DELEGATED OFFICER REPORT

Site Address: Havant Thicket Winter Storage Reservoir, Manor Lodge Road, Rowlands Castle.

Proposal: Application for Non- Material Amendment under Section 96A of the Town and Country Planning Act 1990 (as amended) relating to the Southern Embankment of the hybrid planning permission reference APP/24/00312 dated 6th December 2024.

Application No: APP/25/00837

Figure 2: Approved and Proposed Slope Angles

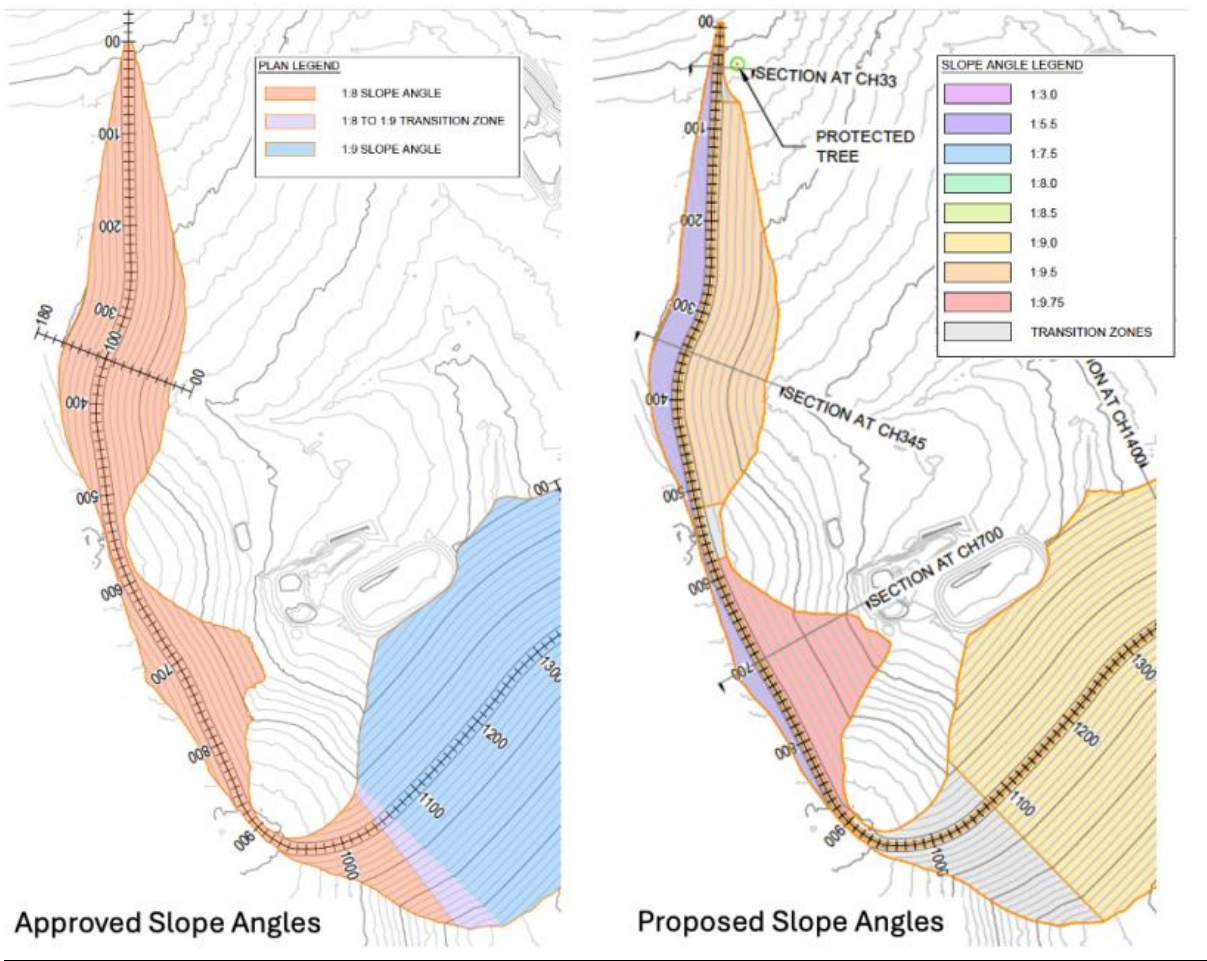
- 3.5 The proposed NMAs to the slope angles are illustrated in Figure 2 below and summarised in Table 1. The amendments will comprise the following:
- i. Reduce the angle of the inside slopes of the Western Embankment to remove the structural risk. The amendments will generally be below the water line and therefore not readily visible.

- ii. Increase the angle of the outside slopes of the Western Embankment. There are no changes to the alignment of the outer toe of the embankment or to the height of the embankment. Views of the outside slopes of the Western Embankment are limited and largely screened from the nearest residential properties by existing vegetation which will be maintained and reinforced as part of the landscaping for HTR.

- iii. Alter the Transition Zone from the Western Embankment to tie in with the Main (Southern) Embankment slopes, providing a graded change between the embankments. As a result of these NMAs, there is no change to the Main (Southern) Embankment beyond the Transition Zone.

- iv. Revise the inside slope angles at the northern extent of the Western Embankment to ensure tree G190 located adjacent to the Western Embankment is retained.

- v. Consequential non-material amendments, including alterations to fencing and gates, the viewing platform, reed beds and amphitheatre.

- 6.16 The proposed amendments to the slope angles are summarised as follows with officer commentary under each change and overall conclusion:
- i. Reduce the angle of the inside slopes of the Western Embankment.
Officer Comments: *The amendments will generally be below the water line and therefore not readily visible and therefore any visual impact will not be perceptible. There are consequential changes to the reed beds to be created adjacent to the Transition Zone though they remain similar in form as approved and subject to landscaping conditions discharge.*

- ii. Increase the angle of the outside slopes of the Western Embankment.
Officer Comments: *There are no changes to the alignment of the outer toe of the embankment or to the height of the embankment. Views of the outside slopes of the Western Embankment are limited and largely screened from the nearest residential properties by existing vegetation which will be maintained and reinforced as part of the landscaping for HTR. It must be noted that the embankment does not move any closer than approved and the angle change would not fundamentally alter the views and perception of the embankment from public vantage points.*

- iii. Alter the Transition Zone from the Western Embankment to tie in with the Main (Southern) Embankment slopes, providing a graded change between the embankments
Officer Comments: *As a result of these NMAs, there is no change to the Main (Southern) Embankment beyond the Transition Zone.*

- iv. Revise the inside slope angles at the northern extent of the Western Embankment to ensure tree G190 located adjacent to the Western Embankment is retained.
Officer Comments: *This change is considered non material as again the change in angle will not be perceptible and overall it would be considered positive as it results in the retention of a mature tree.*

Figure 3: Illustration of Crest Path Realignment

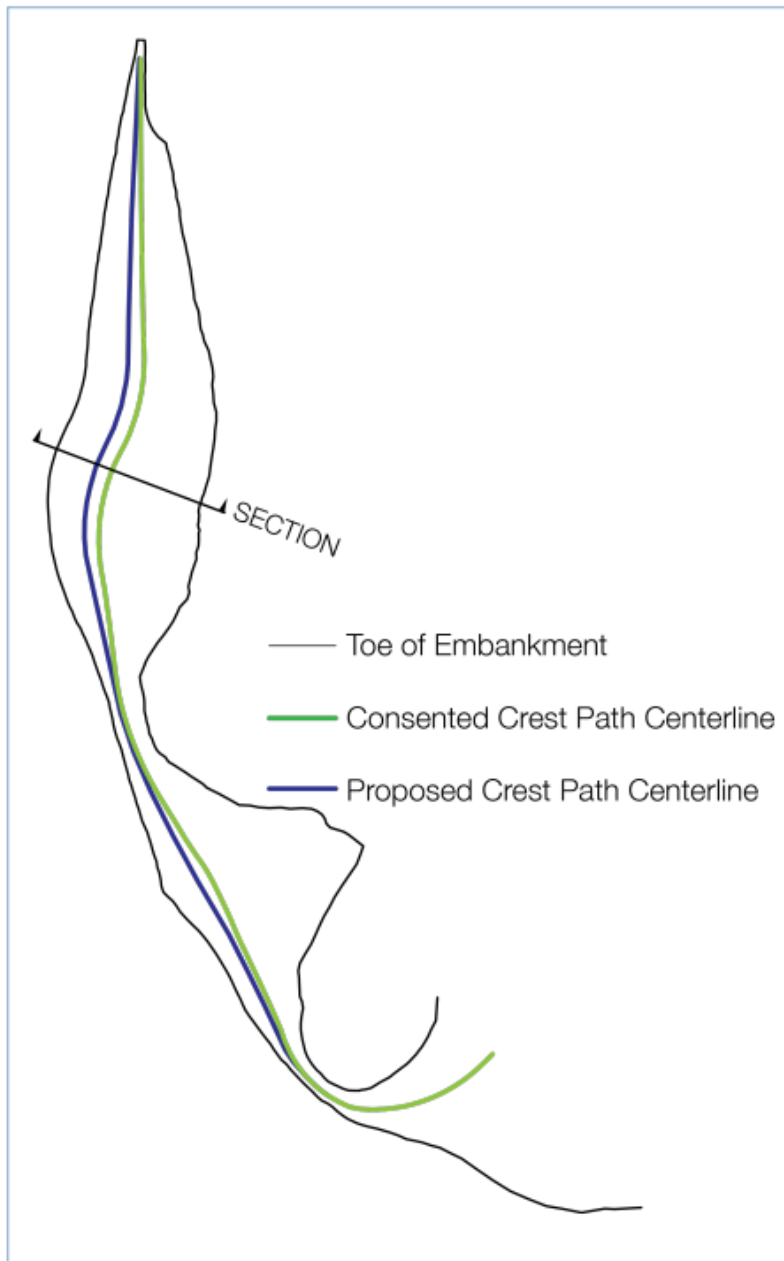
3.6 The proposed NMAs require the realignment of the crest path on the Western Embankment to account for the revised design as illustrated in Figure 3 below.

- 6.17 The realignment of the crest path will continue to follow the route of the ridge of the embankment, and the amendments will be largely imperceptible when viewed in the context of the wider reservoir development. The function, form and use of the path will remain as intended and approved.

Figure 4: Crest Path at Chainage 350

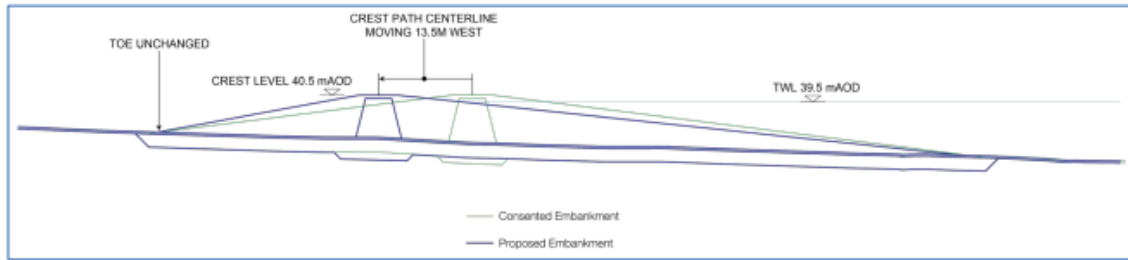
- 3.7 The amendments to the crest path would result in the crest path moving 13.5m west at approximately chainage 350 (as illustrated in Figure 4 below). The Crest path moves 10.5m west at chainage 700. This results in a 2m increase in the overall length of the embankment to 2,850m.
- 3.8 It is noted that the length of the crest path length is detailed as 2848m on the approved Section 73 permission plans but Condition 2 on the S73 decision notice was not updated and references the length as 2,800m. It is proposed that the NMA will update Condition 2 to reflect the proposed NMA to 2,850m.
